CITY OF YPSILANTI
Agenda
Historic District Commission
Tuesday, April 24, 2018 - 7:00 p.m.
SPARK East, 215 W Michigan Ave
Ypsilanti, MI 48197

V. BUSINESS SESSION

1. 116-118 W Michigan

Front & rear façade work; window & door replacement & window reopening, roof deck & balcony installation, rear expansion, painting & cleaning

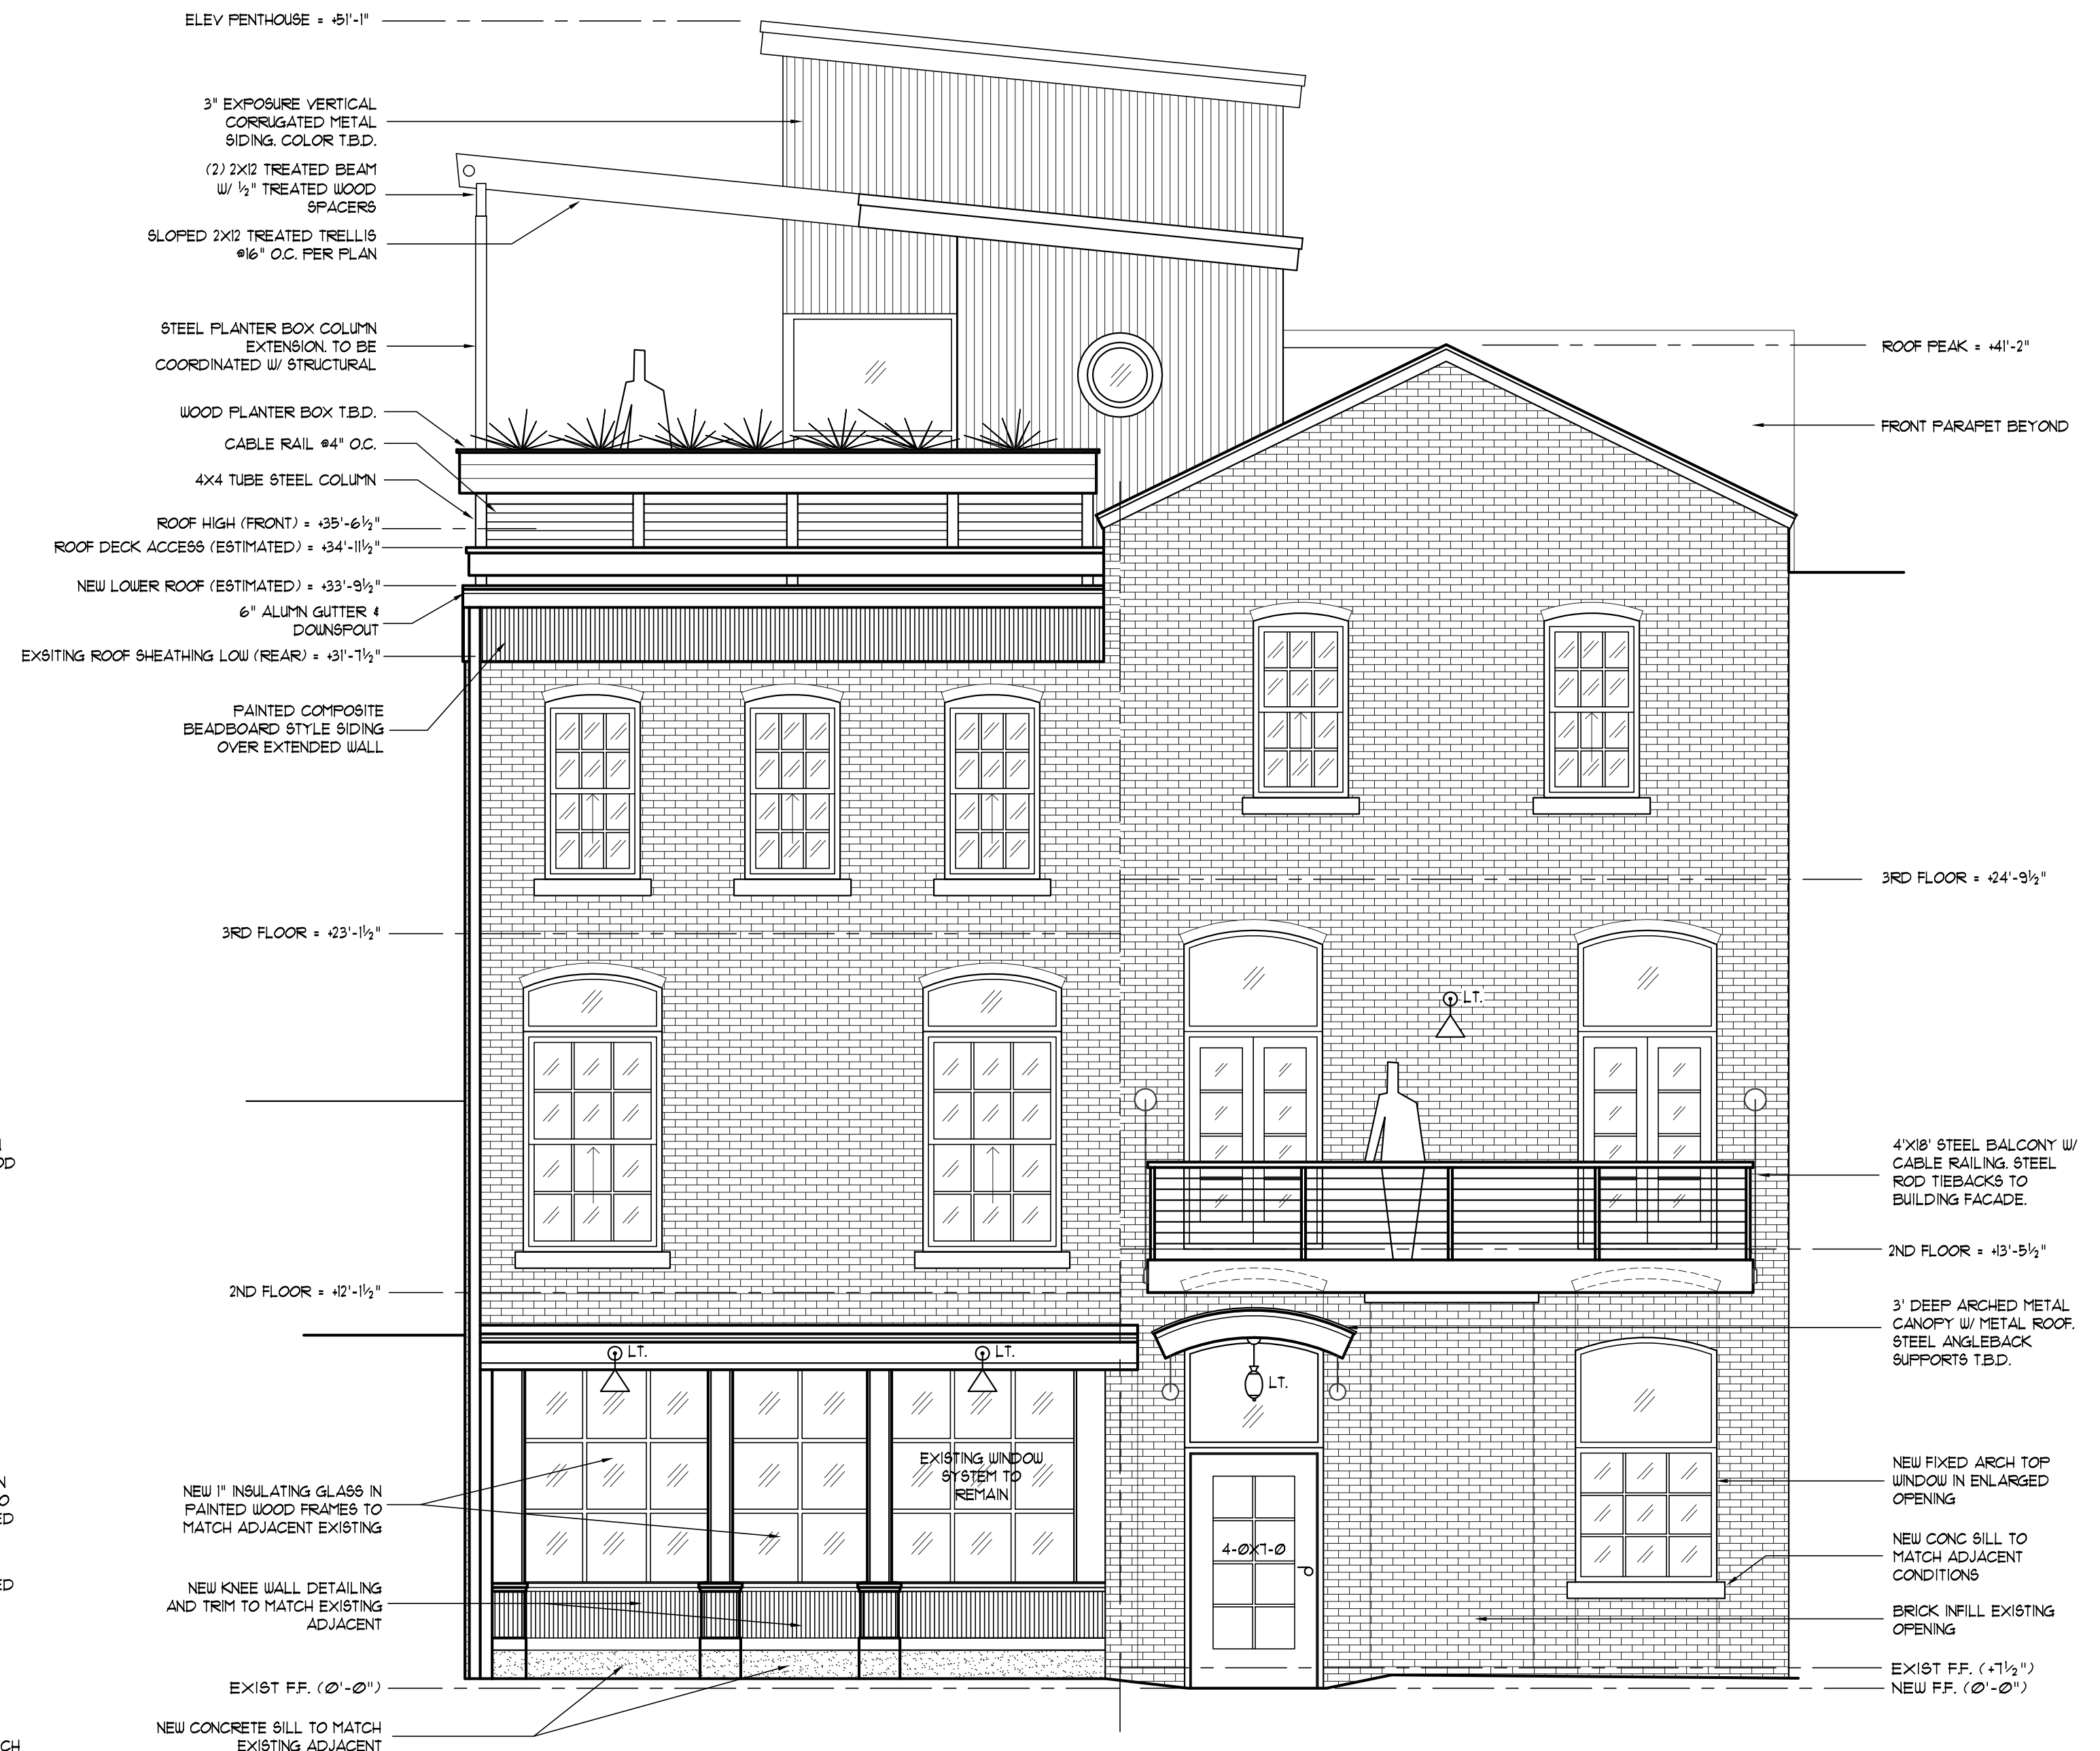
5. The application does not include any details in the application on the windows, paint colors, signage, exterior flooring material, planter box railing nor lighting specs. Other smaller details are missing as well.
